*The Reno Creek ISR Project
Campbell County, Wyoming*

**Revised RAI Response Package:
Technical Report**

December 2014

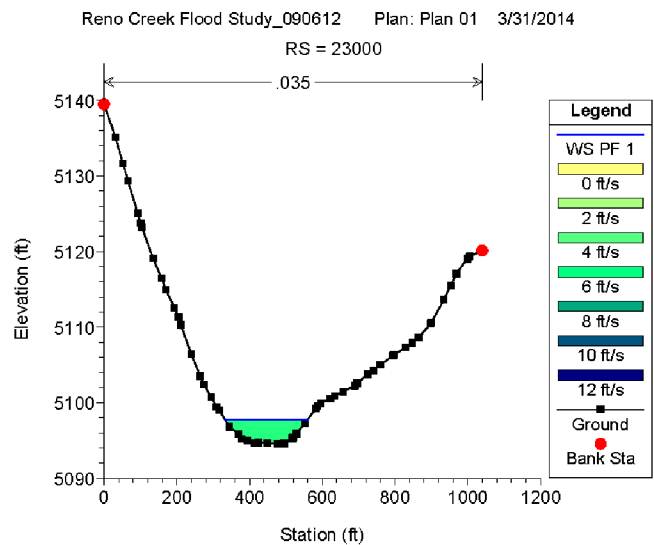
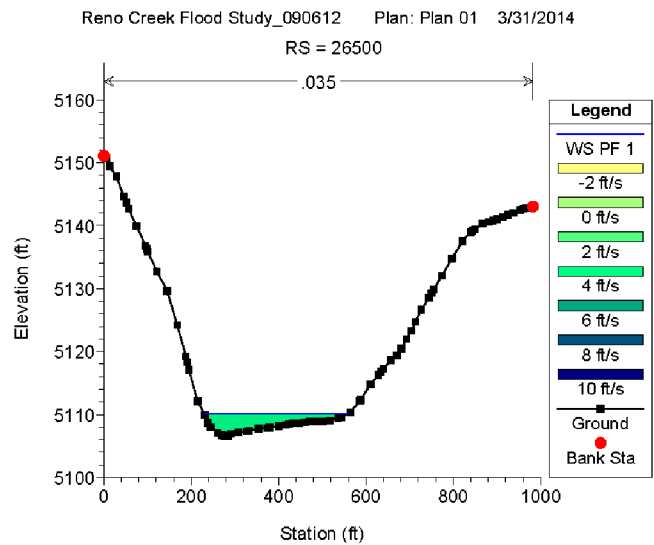
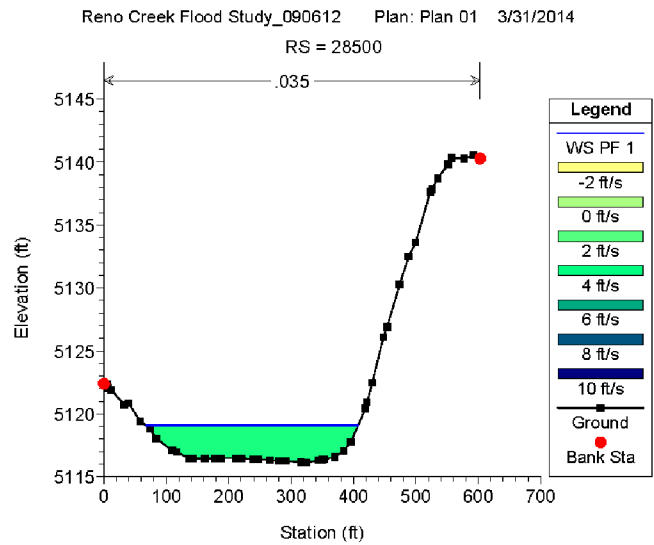
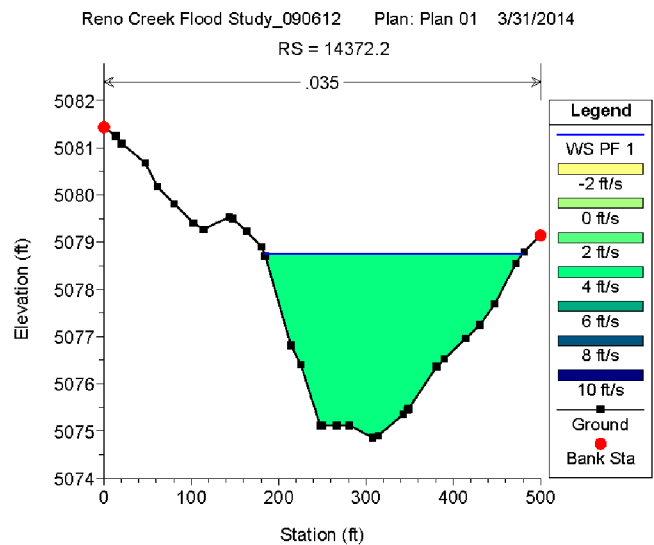
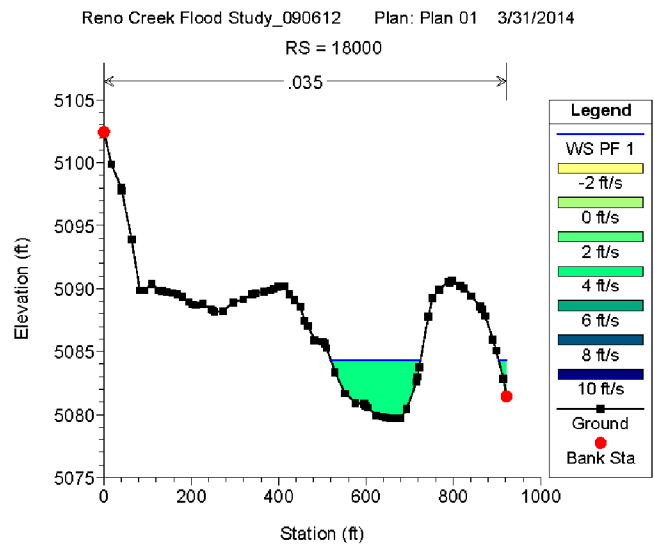
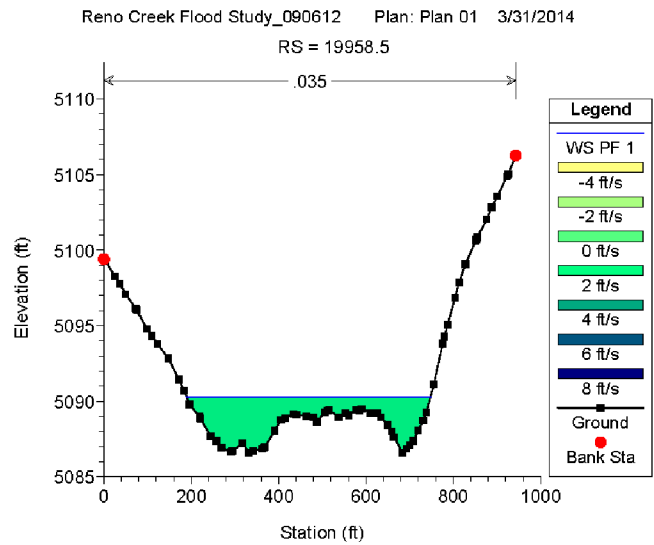
The last sentence in the first paragraph under Section 2.7.1.5.2 states “Figure 2.7A-5 provides cross-section views for each of the 49 cross-sections”; however, Figure 2.7A-5 includes only 12 cross-sections. Furthermore, locations of the 49 cross-sections are not depicted on any figure.

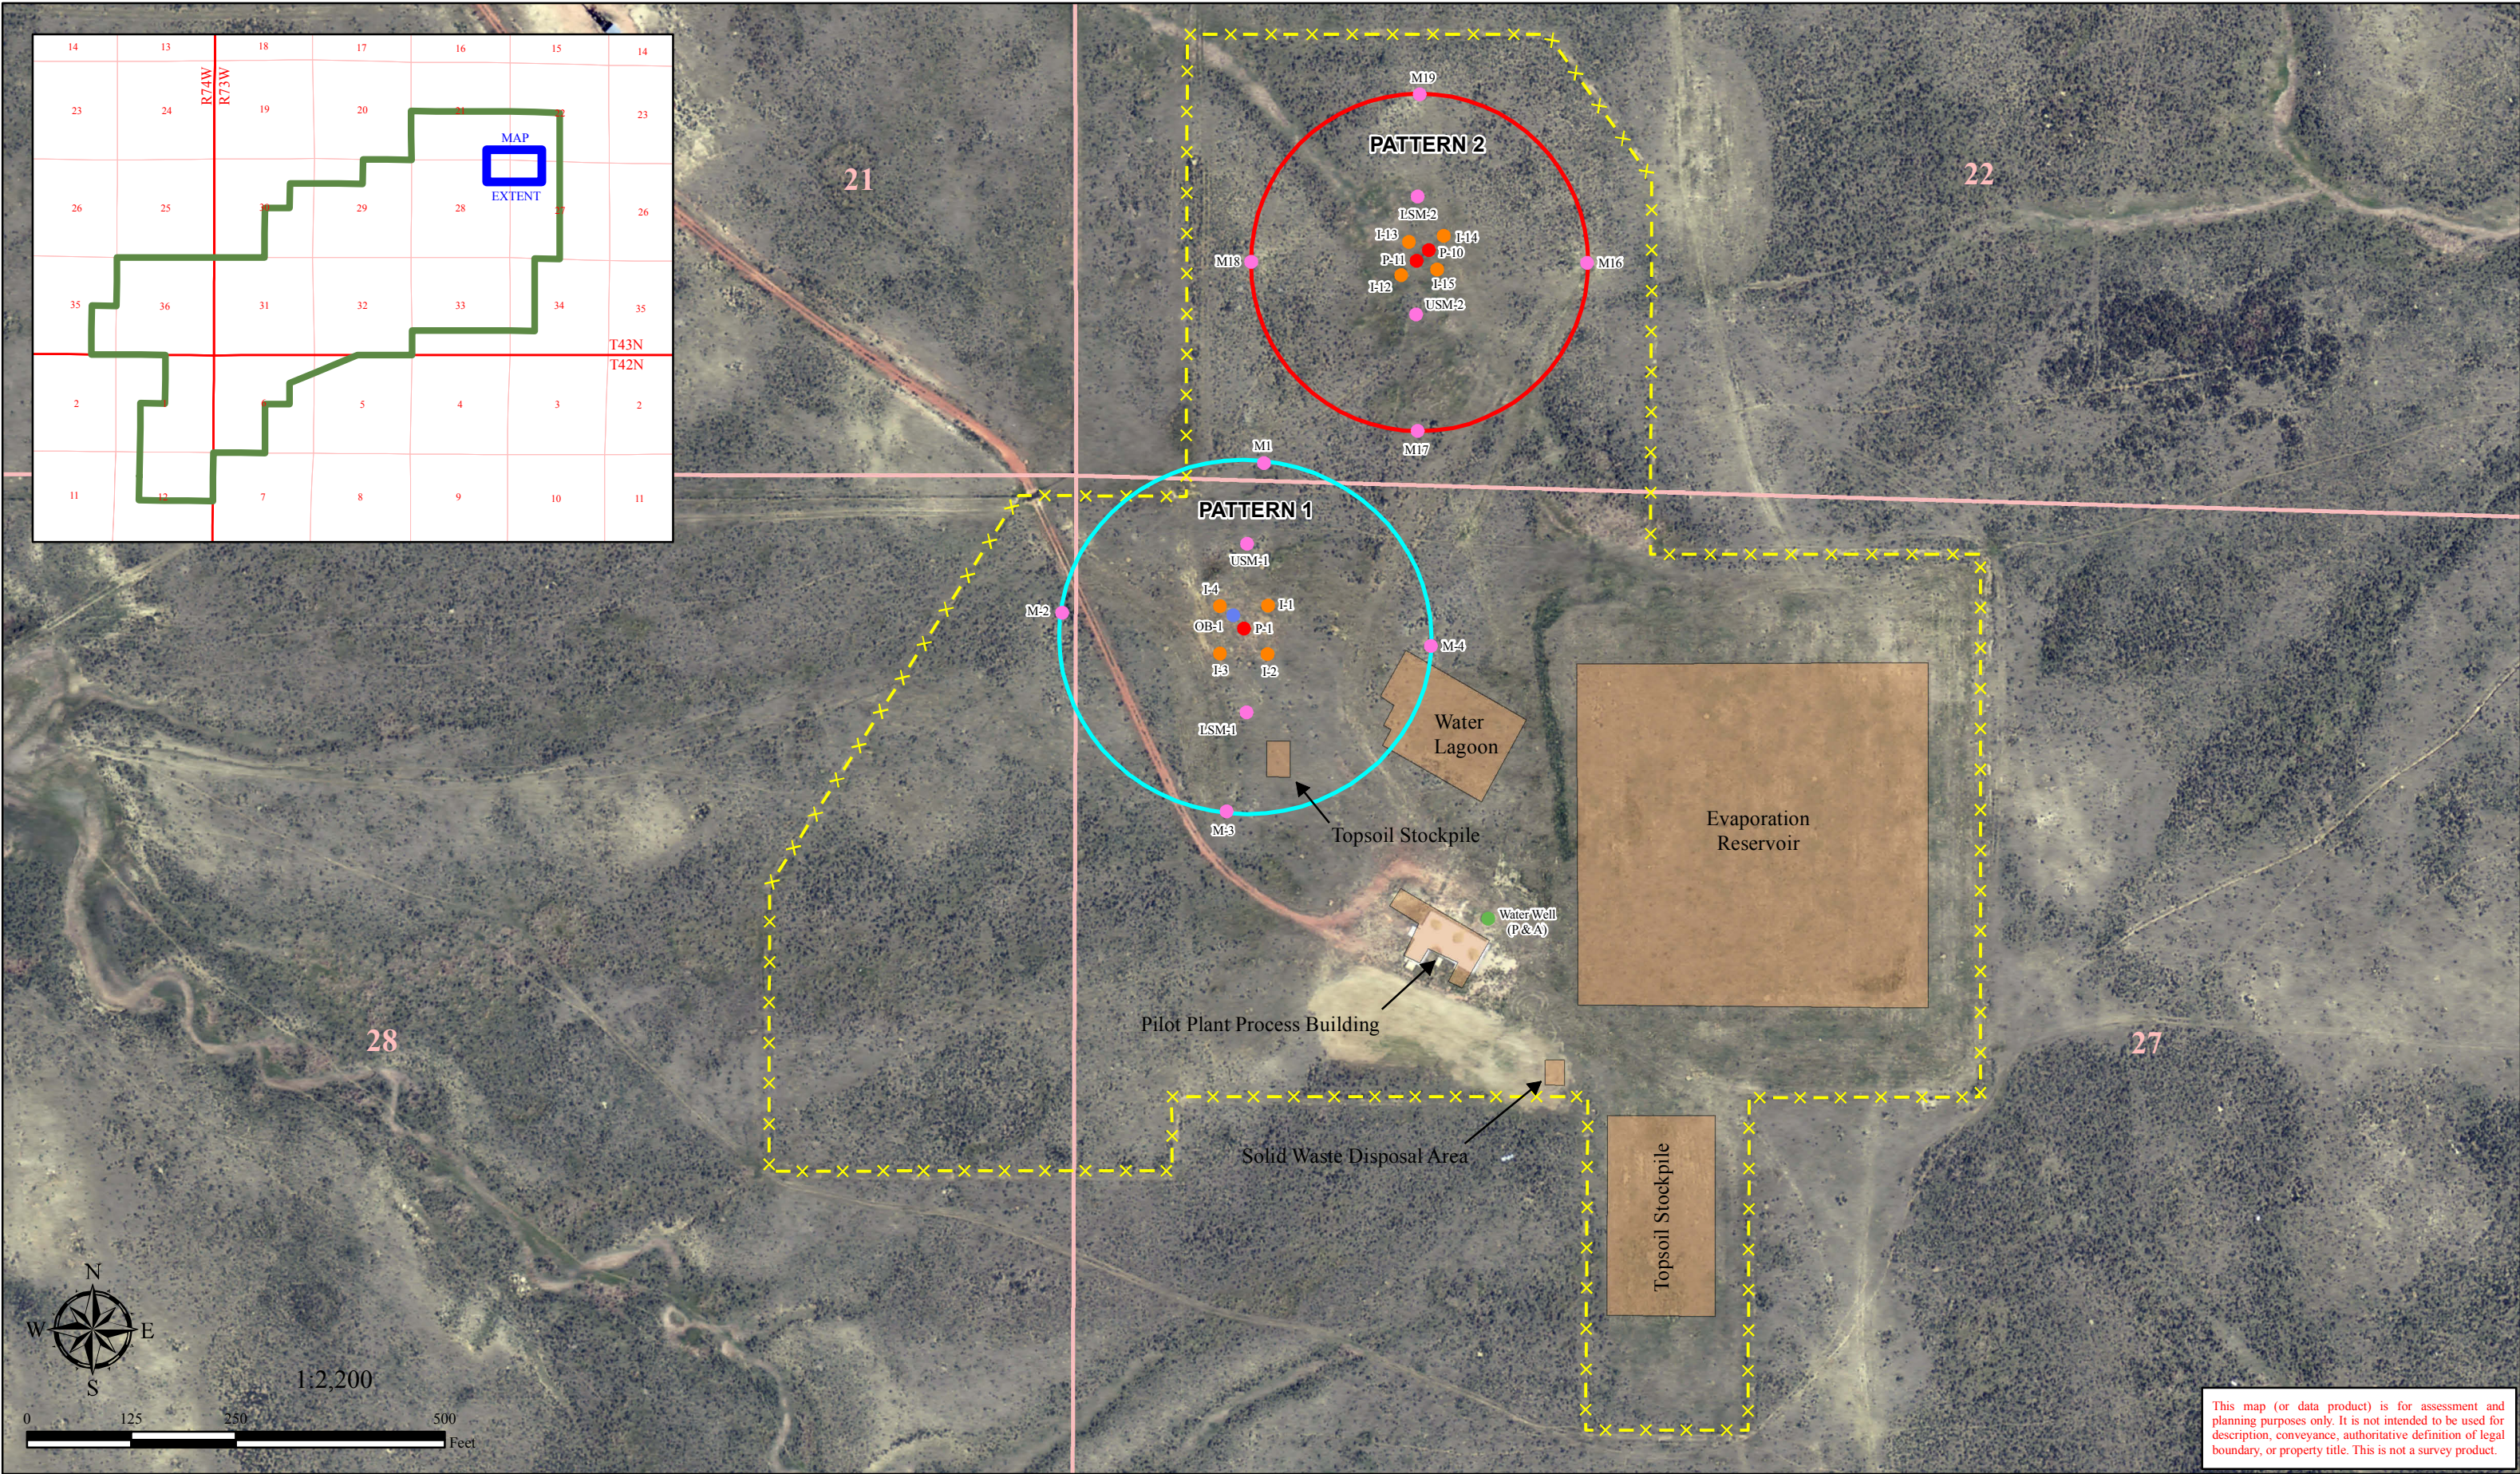
Review of RME’s “Pilot Plant Site Plan” map on page Addendum 1A-64 revealed that the RME map has three errors:

1. Wells I-12 and I-14 are reversed.
2. I-12 should plot at the location of I-14 and vice versa.
3. USM-1 is mislabeled and should be USM-2.
